Subject: DTE Electric Company Revised Response to NRC Request for Additional Information Letter No. 85

1) Response to RAI Letter No. 85 (Question No. 03.07.02-11, Revision 1)

RAI Question No. 03.07.02-11

Figure 46-1: Geometry of Cylindrical Foundation Cross Section

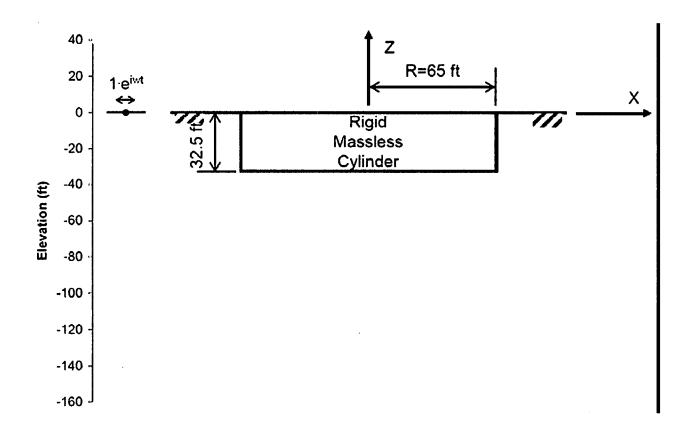
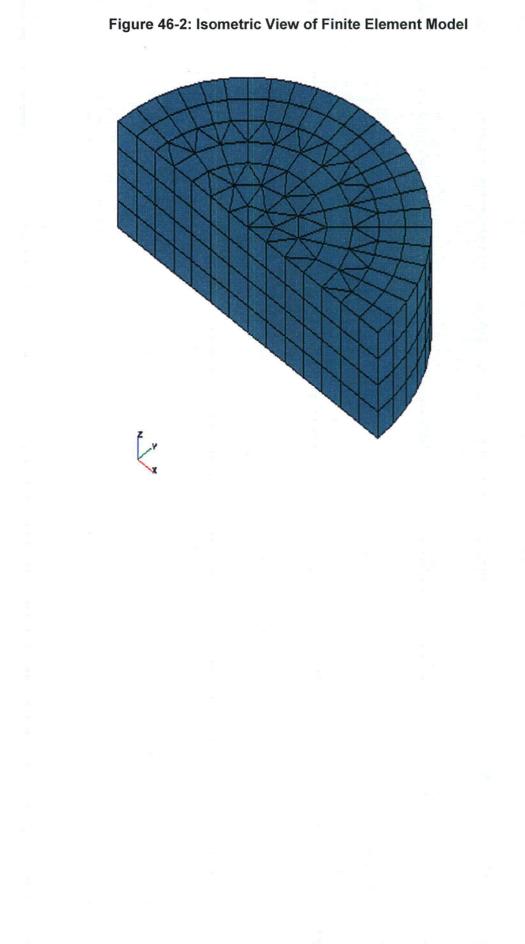
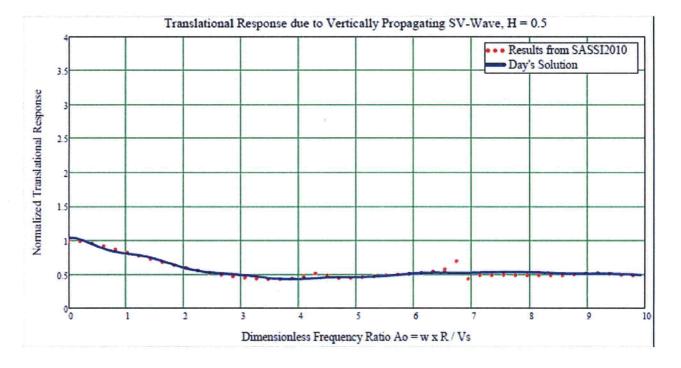
During the audit the staff determined that the test problems did not include validation for transfer functions or impedance functions, for frequencies above approximately 20 Hz up to 50 Hz for the Fermi 3 site.

In accordance with 10 CFR Part 50, Appendix S, to ensure that the seismic SSI analyses performed using SASSI2010 in support of the Fermi 3 Combined License application are adequate for the full frequency of interest at the Fermi 3 site, the applicant is requested to supplement the SASSI2010 V&V with additional test problems that address the issue identified above. This RAI also supplements RAI 03.07.02-9.

The geometry of the model is shown in Figure 46-1 and the isometric view of the finite element model of the rigid, massless structure is shown in Figure 46-2. Figure 46-2 also shows the excavated volume. The excavated soil and the rigid, massless structure are attached to independent internal node sets. On the perimeter of the excavation, the excavated soil and the rigid, massless structure are attached to the same nodes. As shown in Figure 46-2, only half of the foundation is modeled. Symmetry about the XZ plane is used to reduce the size of the problem. The foundation radius, R, is equal to 65 ft, and the embedment depth is 32.5 ft. This results in an embedment depth to foundation radius ratio of 0.5 (dimensionless parameter H). The parameter H = 0.5 is selected because Day's solution is provided for H = 0.5, H = 1.0, and H = 2.0. For the Fermi 3 RB/FB, the H value is 0.6 (embedment depth of about 65.6 ft and equivalent radius of about 108.4 ft.), which is close to Day's reported value of H = 0.5.

Figure 46-3 shows the comparison of translational responses (transfer functions) from SASSI2010 and Day's solution. Figure 46-4 shows the comparison of rocking responses (transfer functions) from SASSI2010 and Day's solution. The results are plotted for  $A_0$  values up to 10 (about 50 Hz). The transfer functions are for the center node at the base of the rigid massless cylindrical foundation.

Based on these comparisons, it is concluded that the results from SASSI2010 and the results reported by Day (Reference 1) are in good agreement, except at an  $A_0$  value of about 6.8, where the SASSI2010 response value is about 30% higher. This is an isolated deviation and its impact on the total response from SASSI2010 analysis is negligible.
